PG&E Letter DCL-03-047

Docket No. 50-275, OL-DPR-80
Docket No. 50-323, OL-DPR-82
Diablo Canyon Units 1 and 2
Response to NRC Request for Additional Information Regarding License
Amendment Request 02-03, "Spent Fuel Cask Handling"

**PG&E Response to NRC Request for Additional Information Regarding License
Amendment Request 02-03, "Spent Fuel Cask Handling"**

SAFETY ANALYSIS REPORT
DIABLO CANYON ISFSI
FIGURE 5.1-1 (1 of 3)
OPERATION SEQUENCE FLOWCHART
FOR CASK SYSTEM LOADING,
SEALING, TESTING, AND STORAGE

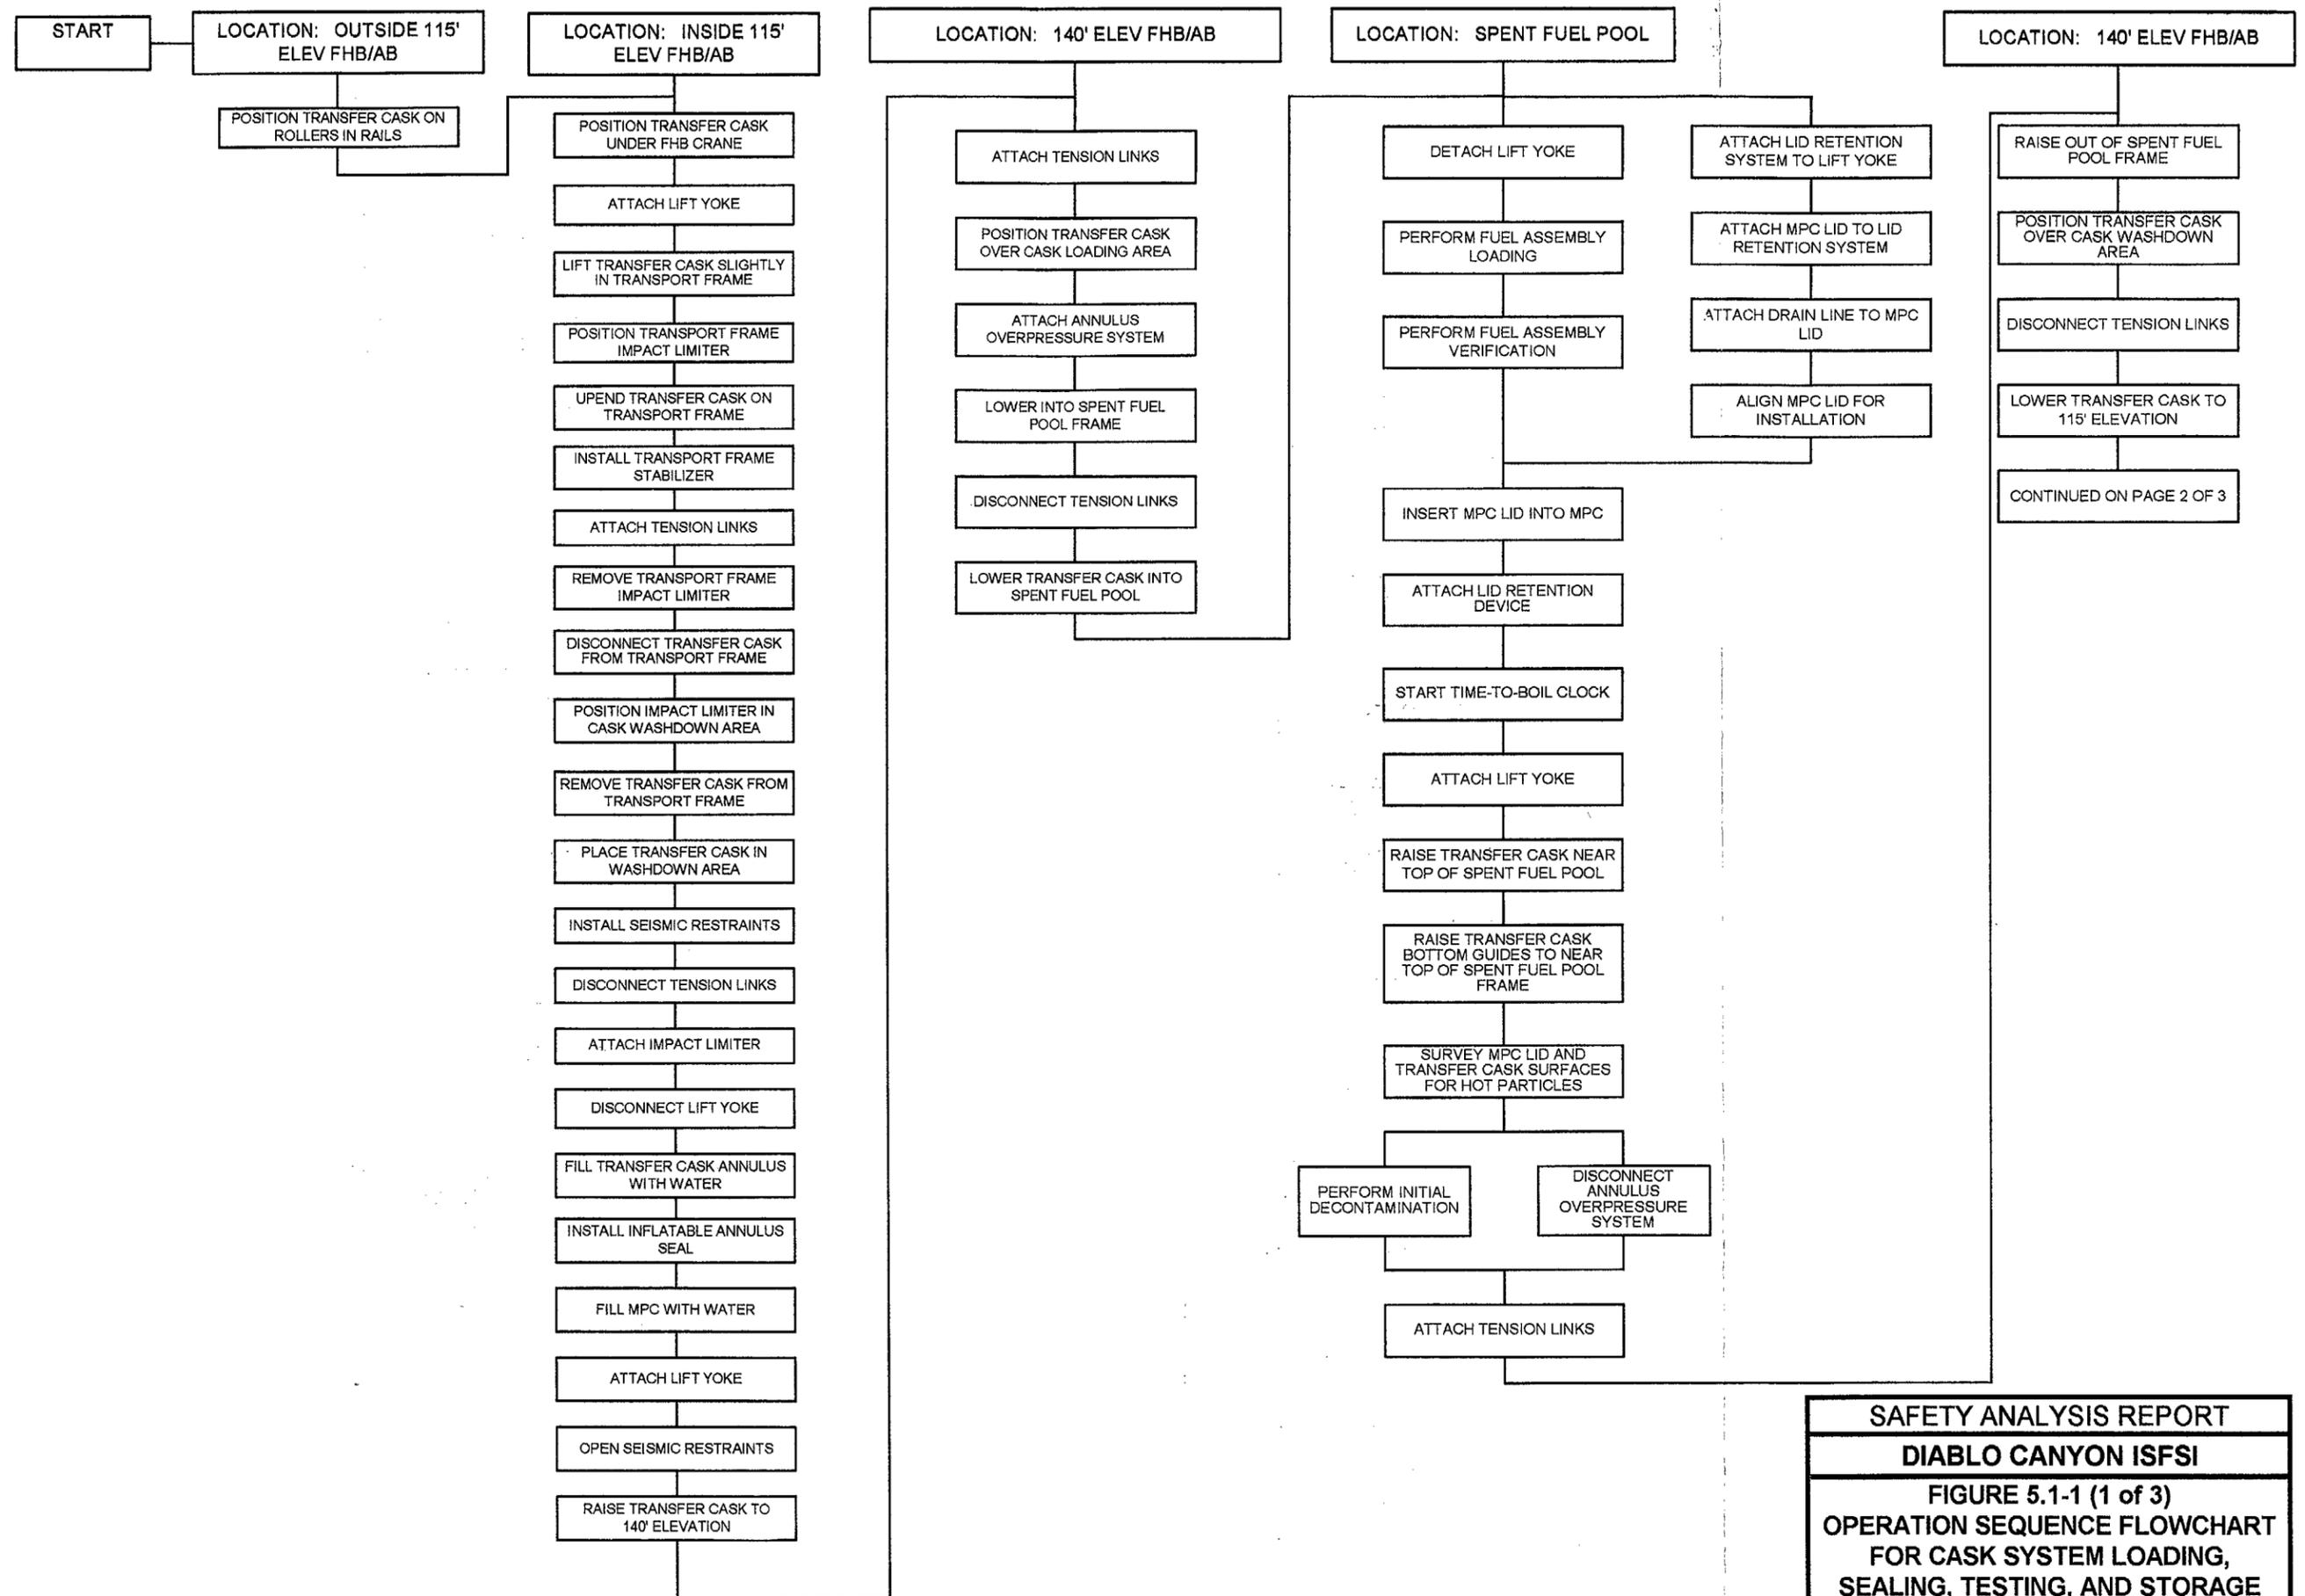
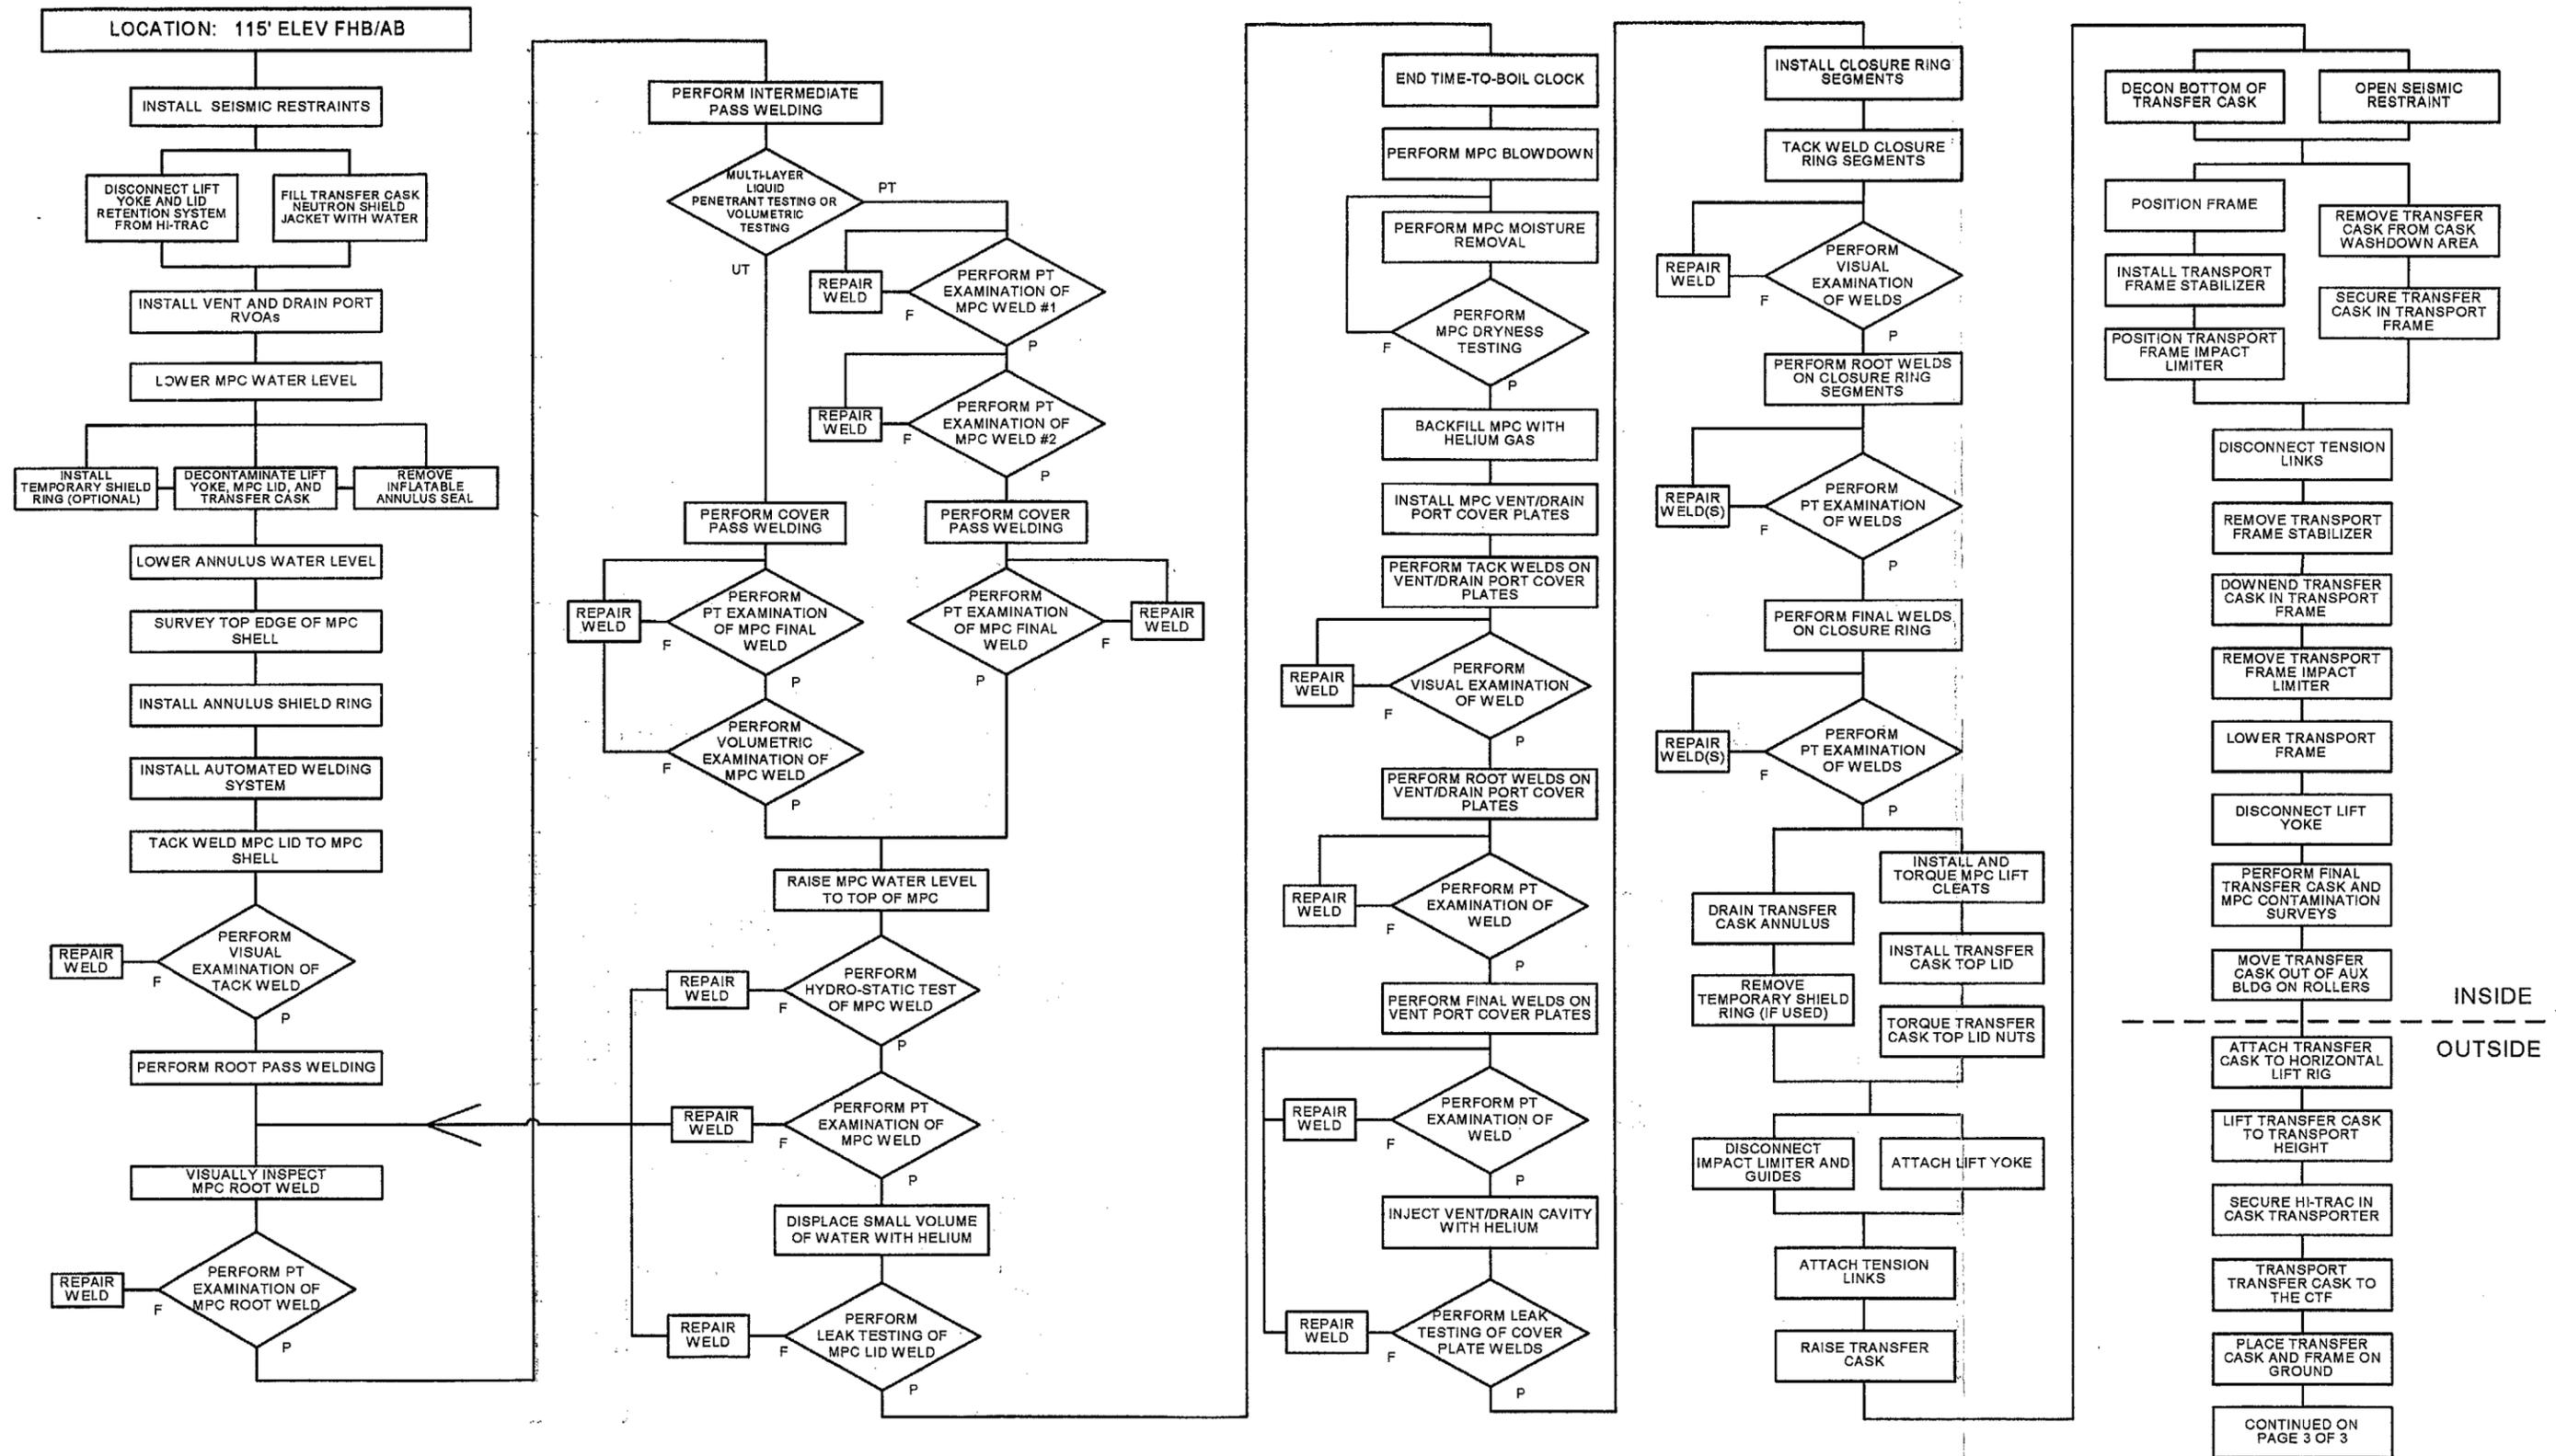
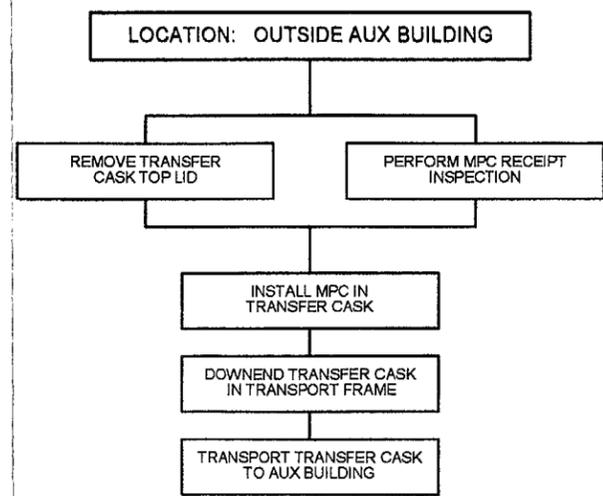
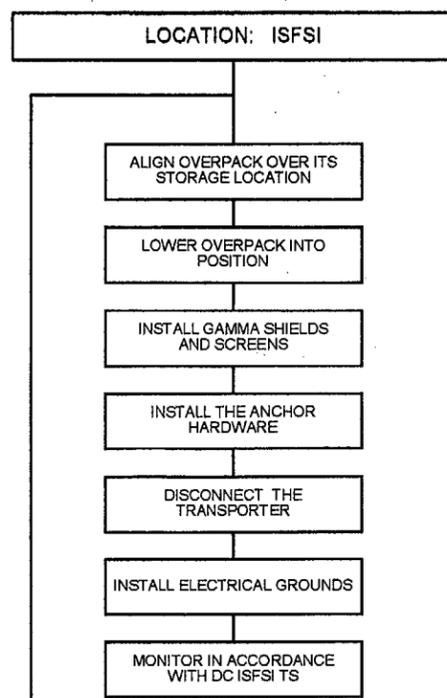
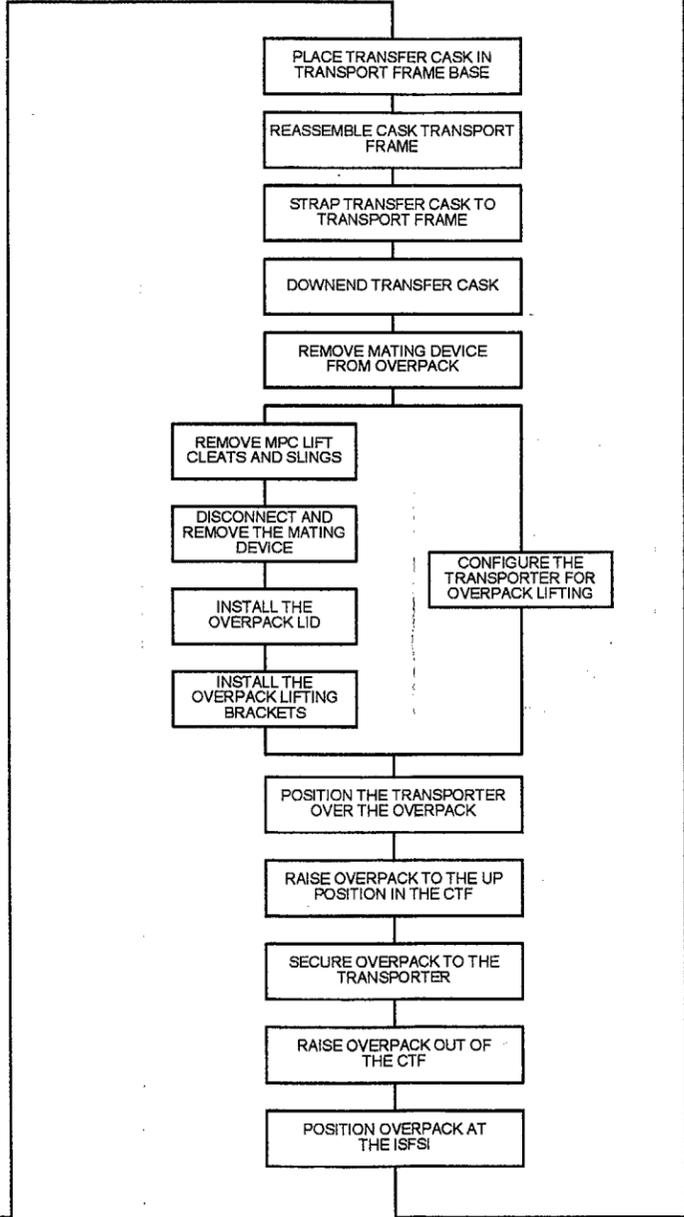
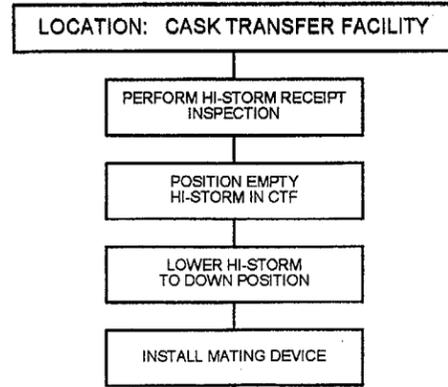
The Diablo Canyon Power Plant (DCPP) license amendment request to revise the DCPD updated final safety analysis report (UFSAR) regarding its control of heavy loads program proposes to eliminate the spent fuel cask exclusion zone. The UFSAR restricts cask movement to the portion of the spent fuel pool which is over the cask recess area. The defense-in-depth approach within NUREG-0612, "Control of Heavy Loads at Nuclear Power Plants," states that despite the increase reliability of the overhead handling system licensees should (1) provide sufficient operator training, handling system design, load handling instructions, and equipment inspection to assure

reliable operation of the handling system; and (2) define safe load paths through procedures and operator training so that to the extent practical heavy loads avoid being carried over or near irradiated fuel or safe shutdown equipment. Provide your basis for eliminating the cask exclusion area? Demonstrate how the defense-in-depth philosophy described will be maintained through your cask handling operations supporting your proposed independent spent fuel storage installation (ISFSI).

An operational sequence depicting the cask handling operations is presented in the enclosed Diablo Canyon ISFSI SAR Figure 5.1-1, which was previously submitted in PG&E Letter DIL-01-002 dated December 21, 2001 under Docket No. 72.26. Using LAR Figures 8 and 9 along with the sequence presented, provides a "pool to pad" map of cask handling operations.
